**Representation in response to Initial Assessment Report - Kangaroo Bay Hotel
Major Project**

Kangaroo Bay Hotel Major Project

Representation to the Assessment Panel's Initial Assessment Report

The location of the boreholes within the Project site is shown in the figure below.

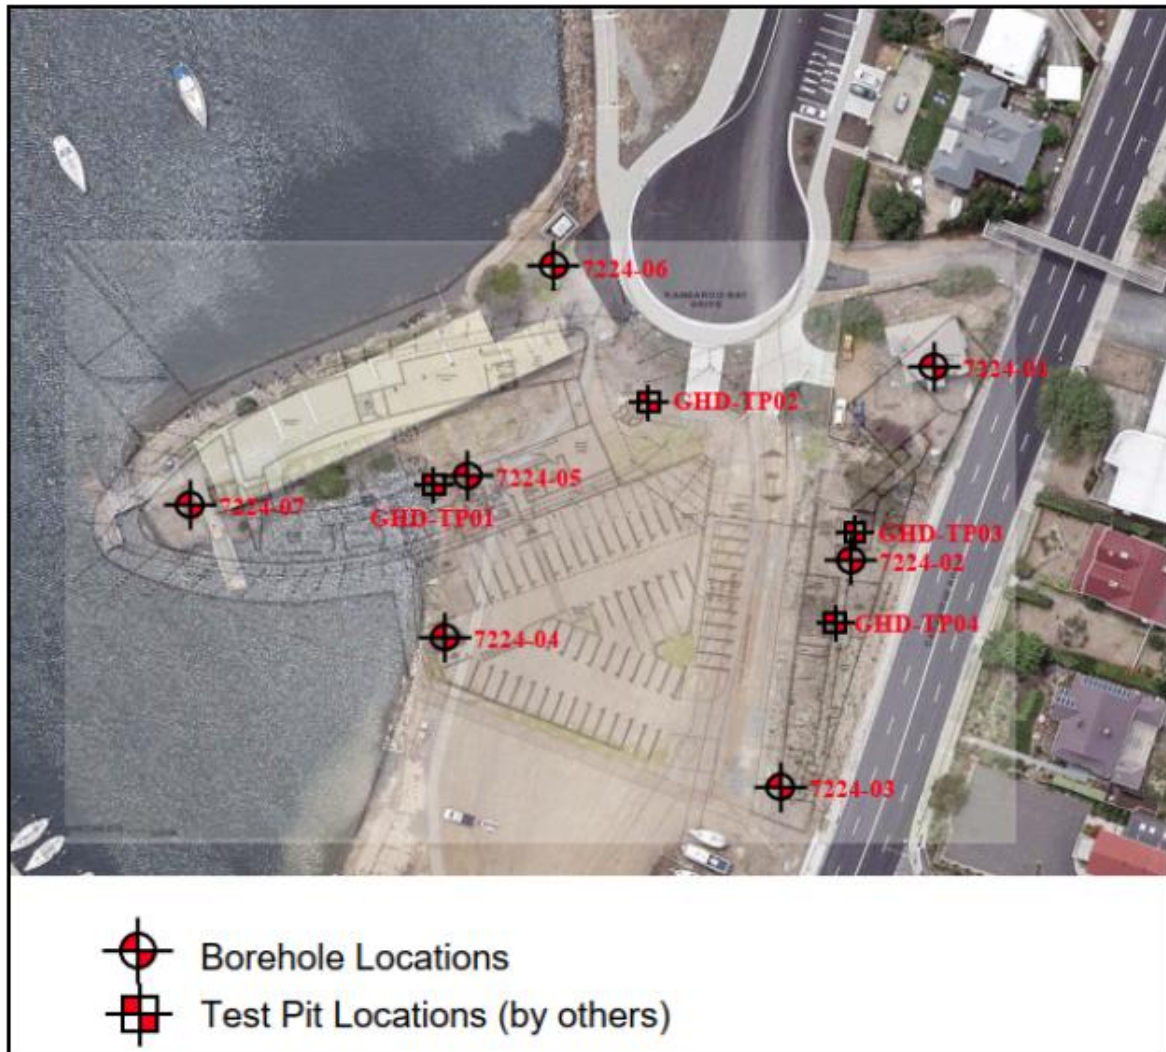
- The summary in Volume 1 states that no work is occurring within Timtumili Minanya/River Derwent. However, the proposed use and development plans show one overhanging section of the public walkway along the foreshore requiring a structural support that appears to be constructed within the river. The proposal plans also indicate some 'sandstone steps' will extend below the waterline.
- There is limited information provided on groundwater flows.
- Draft permit conditions recommended by the proponent in Volume 1 do not fully reflect the recommendations in the technical reports.

Based on the information above, the values which are on the site show groundwater at approximately 0.4m AHD. For stormwater, the raingardens are the most likely assets to be impacted by groundwater. Based on the site level of 2.7m AHD and a depth of these features of 600mm, the base should be above groundwater levels. The features are also lined with an impermeable liner which will stop the ingress of groundwater and therefore not impact on the hydraulic capability.

Groundwater during construction is to be managed by the contractor.

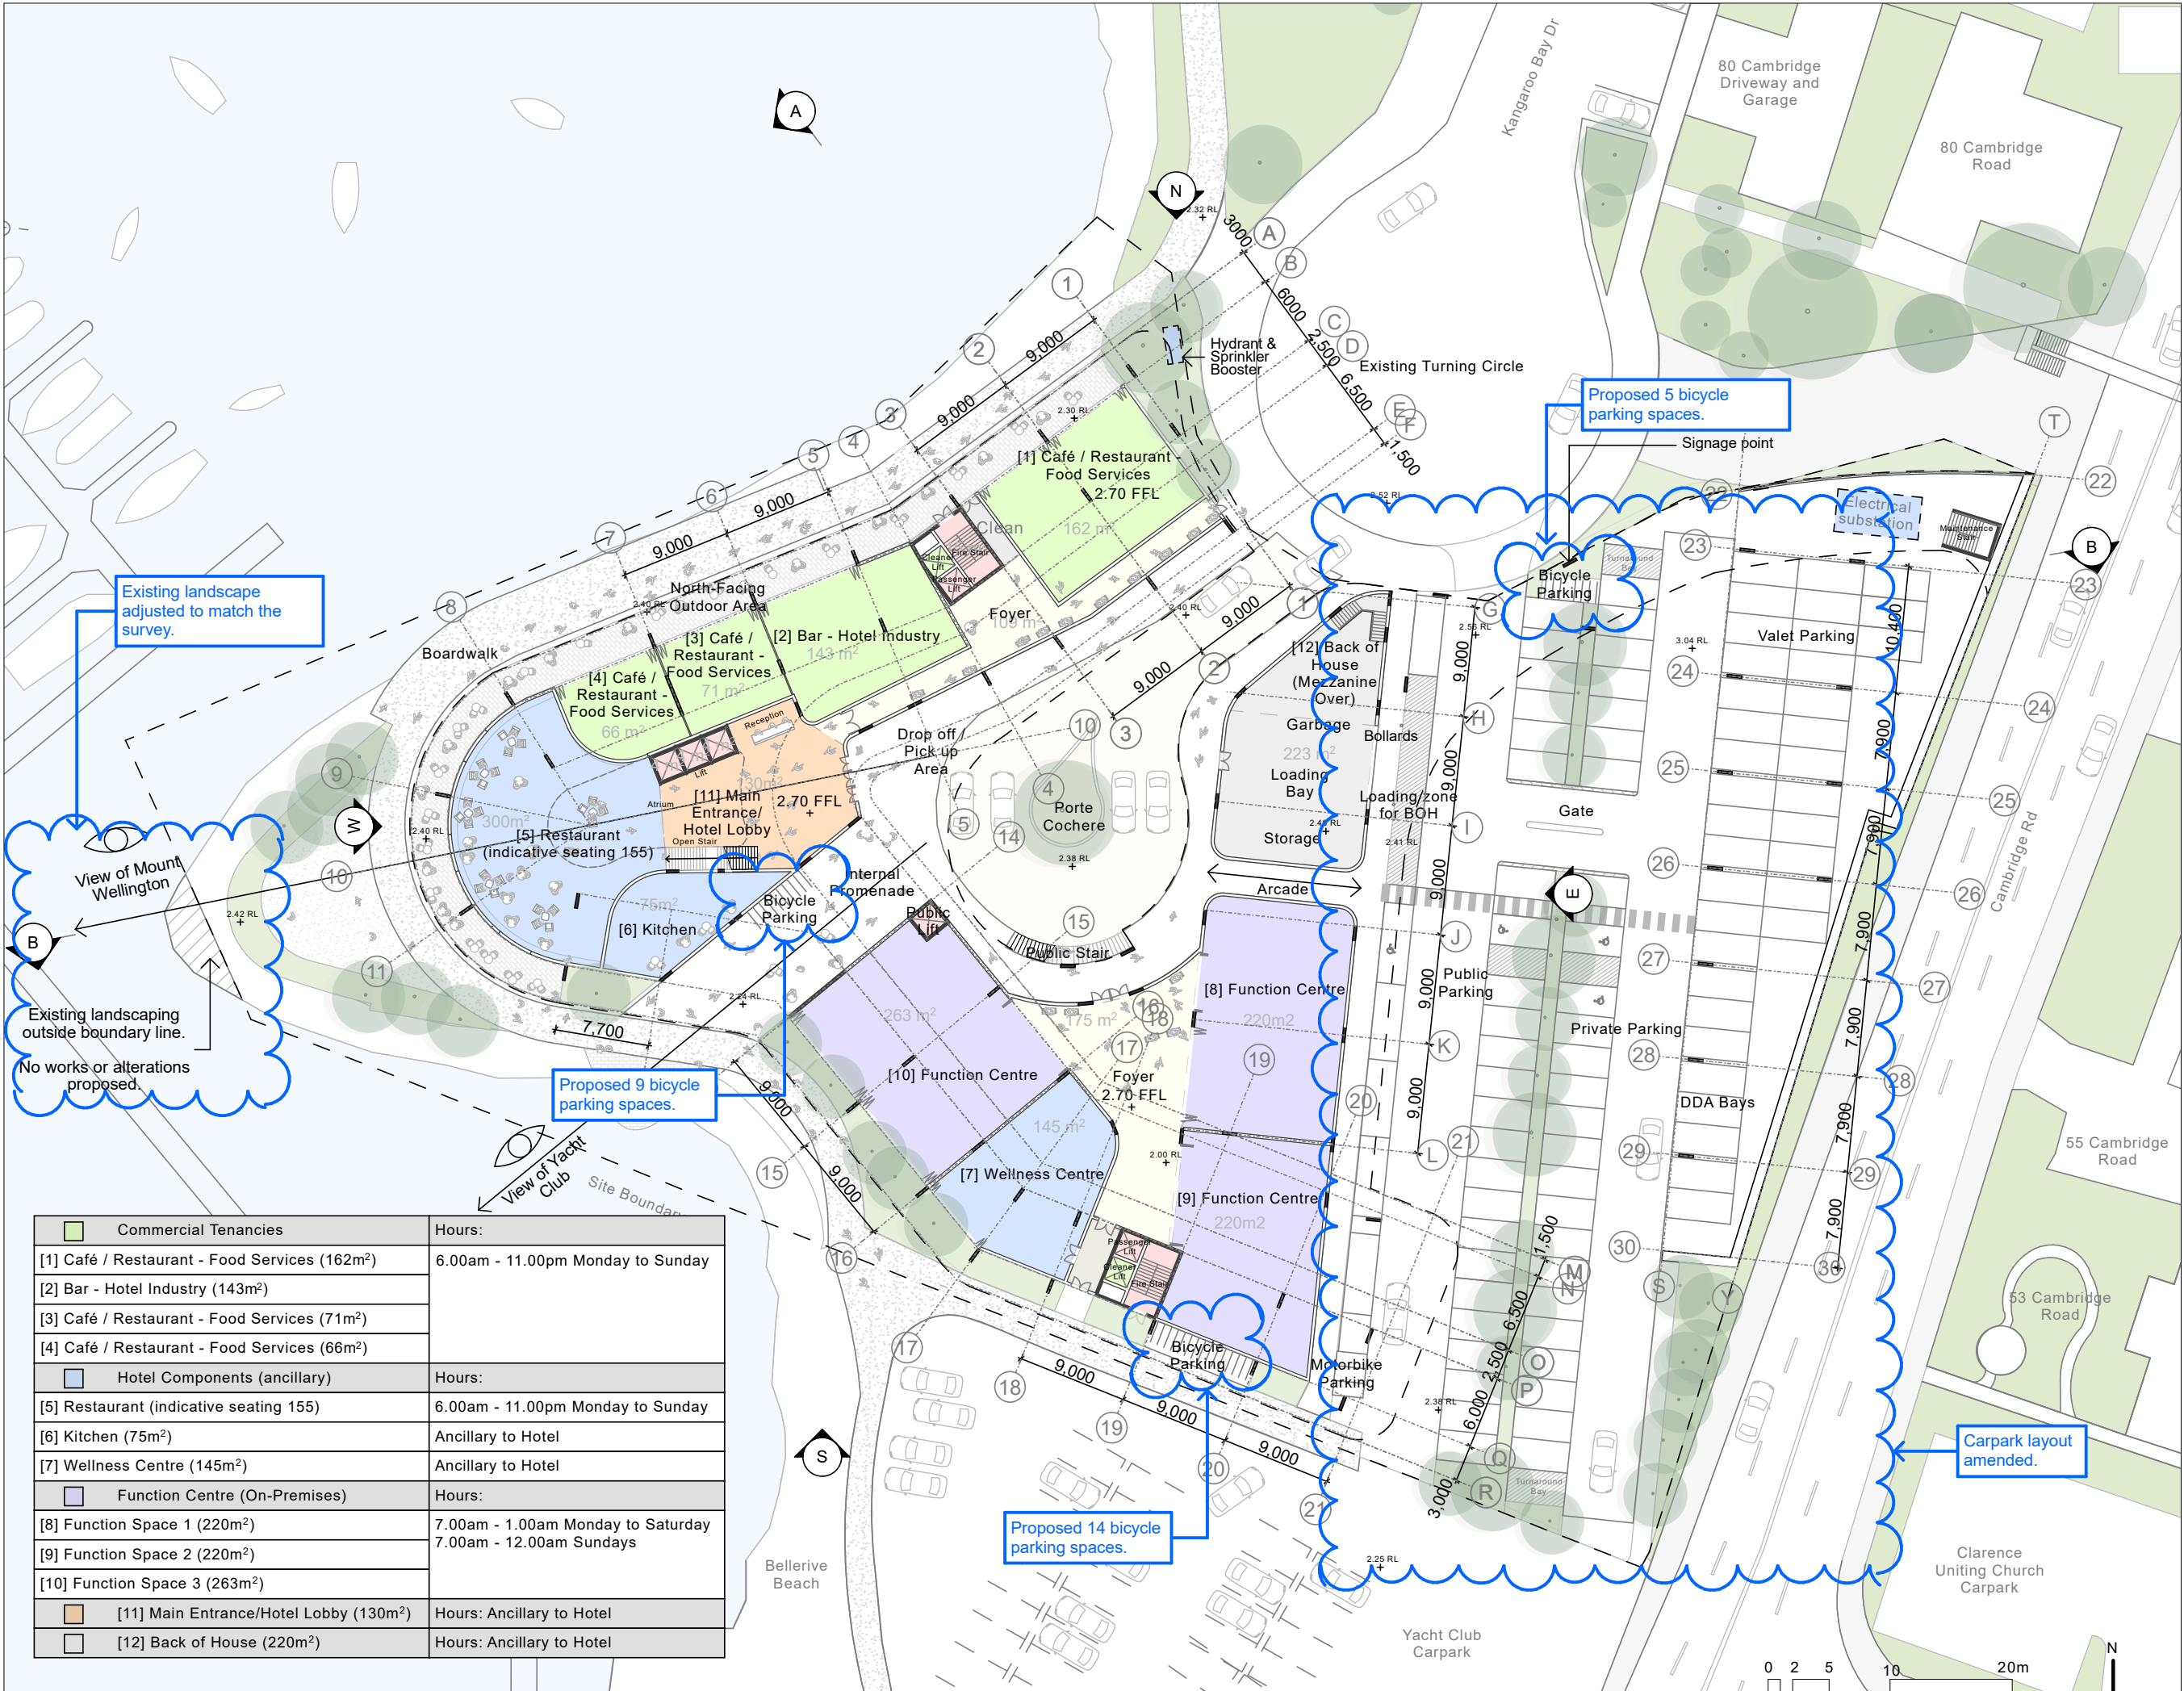
- the site plan showing proposed uses, titled 'Key Plan' in Volume 2, shows the site boundary inaccurately.

Item 1 of Attachment B to this Representation is a revised site plan to match the survey, including existing landscape outside bounding line.

The architectural ground floor plan has also been updated to address minor layout variations and align with the Car Parking Layout Plan. These updates are reflected in the revised architectural ground floor plan A.02 contained within Attachment B of this Representation, item 1.

Plan	IAR reference	Description	Change
1.	Updated ground floor plan (A.02)	1.1, 2.1	Updated ground floor plan A.02 to: • Match survey – include existing landscape outside boundary line. No works or alterations planned for this area • Include proposed bicycle spaces • Carpark layout amendment.	Replace drawing A.02 in MPIS Volume 2, <i>Consolidated Plan Set - Document 1 Architectural & Landscape</i>
